Comments to the Urban Design Commission on the Proposed W. Broadway Development in Urban Design District #1

December 9, 2015

I am writing in regard to the proposed development at 2230 W. Broadway. As an adjacent homeowner, I have concerns about the proposed design and size of the project and its impacts on the aesthetics of both our property and our neighborhood.

October 24, 2015- from our rooftop, across our yard (boundary at fence) and across proposed development site. The tree indicated is of great importance to us.

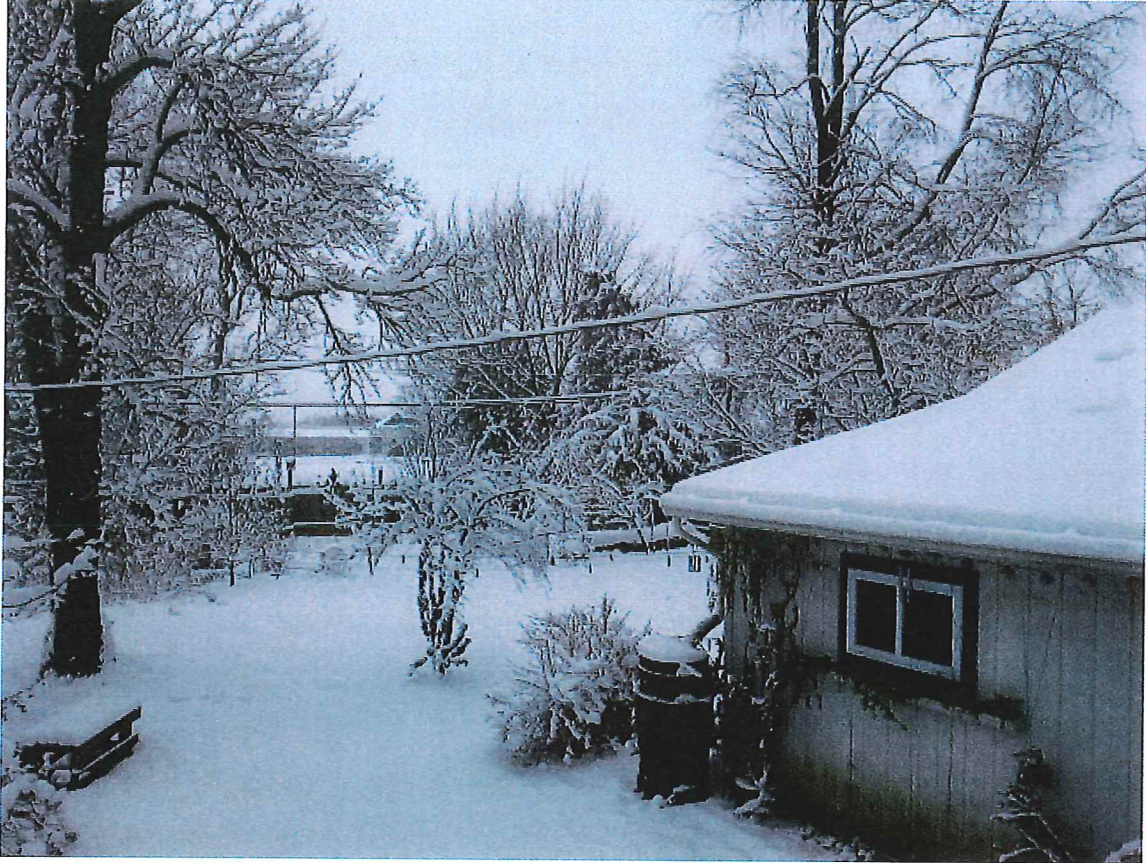
- Insist on preserving the large tree on the development site that is adjacent to SE corner of 2221 Lake Point Dr. lot
- Recommend that developer make every effort to preserve and accommodate other mature trees in the site, and examine current plan shifts that would meet this goal
- Tree plantings should also include species that will in time be very large canopy trees
- Further, replace the planned gingko trees framing the driveway to Fayette. While certainly tolerant of salt and exhaust, they are still a short, ugly, scraggly, non-native species and the "lazy landscaper's" way out. For the love of Adam, find a replacement for all gingkos on site.
